ZAYO'S PRINEVILLE TO RENO PROJECT

CPUC MINOR PROJECT REFINEMENT FORM

Date Requested: 16 Oct 2024	Report No.: 11
Date Approved: 11/6/24	Approval Agency: Caltrans, in addition to CPUC
Property Owner(s): Caltrans (State Route 395 ROW)	Location/Milepost: PM M-0.45 to L-136.55 (N to S)
Land Use/Vegetative Cover: Ruderal (maintained highway shoulder near edge of pavement)	Sensitive Resources: Waterways at culverts to be avoided by boring underneath culverts. Rare plant populations being avoided by change in running line. Cultural resources present, being avoided.(See project webmap.)

The proposed change is a shift of the fiber optic running line from previously submitted engineering drawings. The change entails bringing the running line closer to the highway edge of pavement to avoid construction on slope faces and avoid tree driplines in accordance with the approved Caltrans Encroachment Permit. A portion of the change is being made to avoid a rare plant population.

SHEET NO.: **27 OF 105**

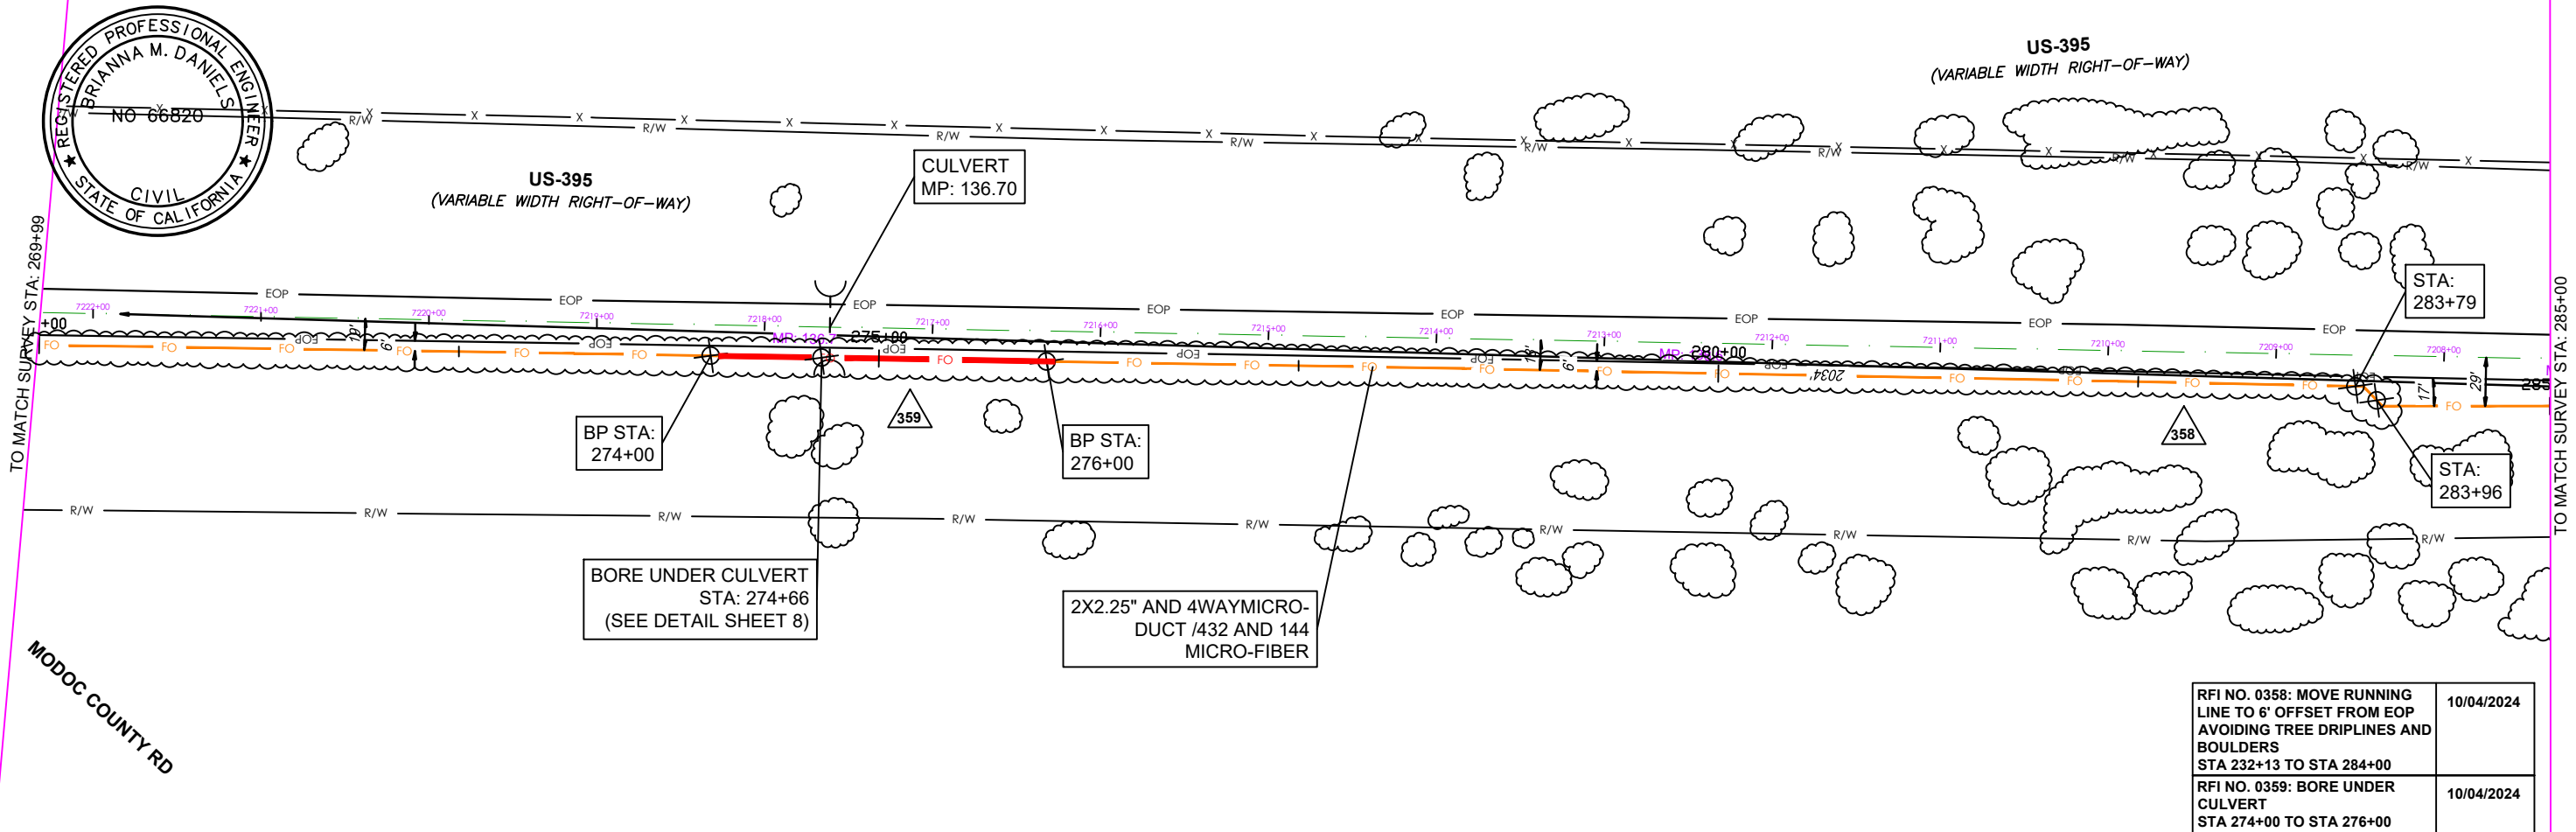
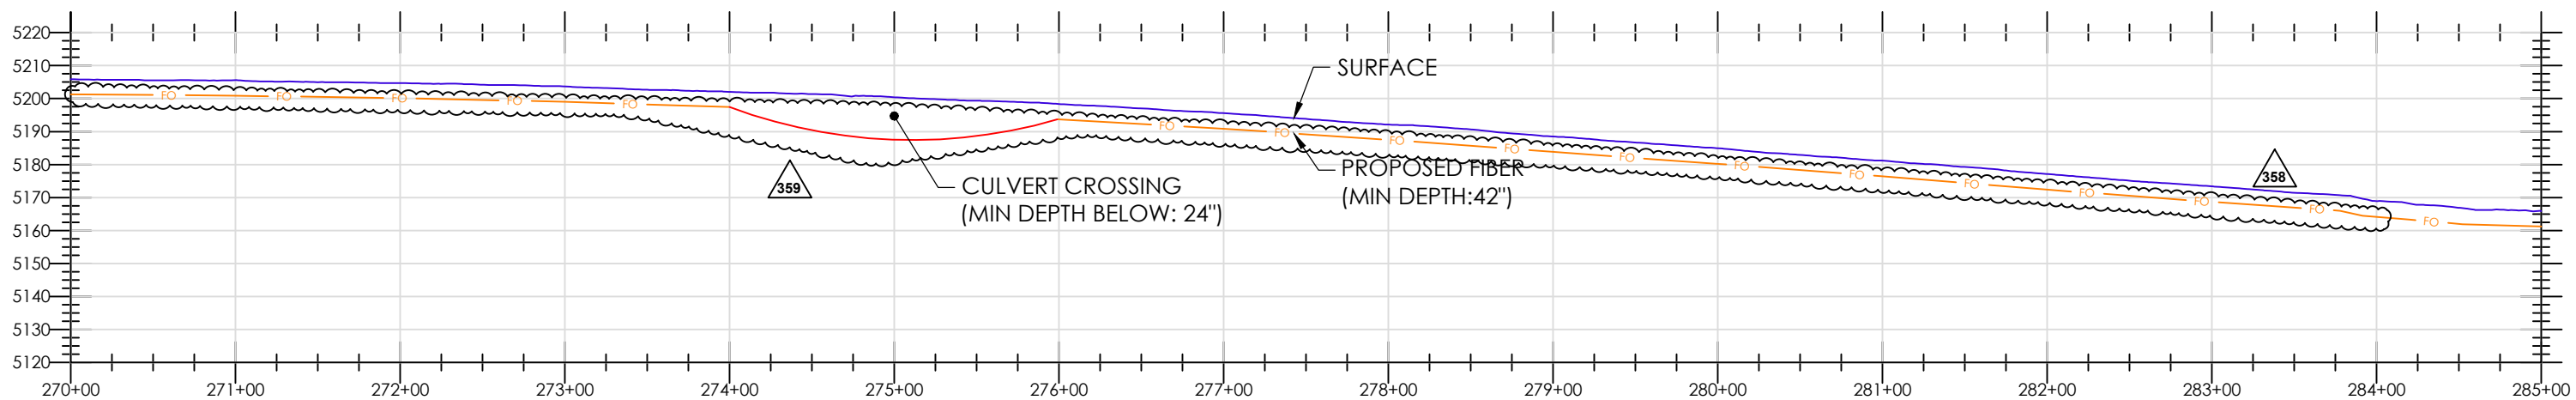
RFI NO. 0358: MOVE RUNNING LINE TO 6' OFFSET FROM EOP AVOIDING TREE DRIFLINES AND BOULDERS STA 232+13 TO STA 284+00	10/04/2024
RFI NO. 0359: BORE UNDER CULVERT STA 274+00 TO STA 276+00	10/04/2024
